P5021A-04

Information Only Service Note

P5021A Keysight Streamline USB Vector Network Analyzer

False alarm on self-test failure on firmware revision of A.13.40.02 - DDR3 memory removal

Self-test

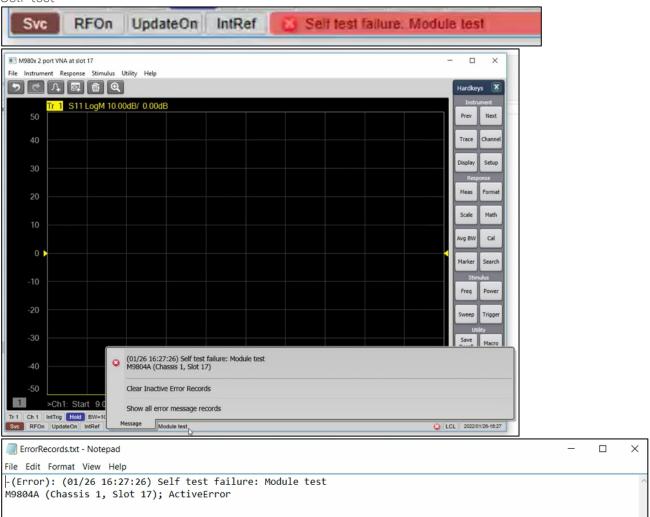
The on board DDR 3 memory in VNA is not in use since its release. With the removal of DDR 3 memory IC on newer P502xA VNA, right after firmware is launched, false alarm (self-test failure) will be reported as shown. This has no impact to VNA performance and specifications.

Similarly, firmware will report a false failure in Operator check. Shown are the error messages example on VNA firmware UI.

Since this DDR3 memory is not in use, newer firmware revision no longer consider it as the failure. Keysight recommends keeping VNA firmware up-to-date whenever it is possible.

For users with firmware revision of A.13.40.02, Update firmware to revision A.13.70.02 or newer to resolve this false alarm on self-test.
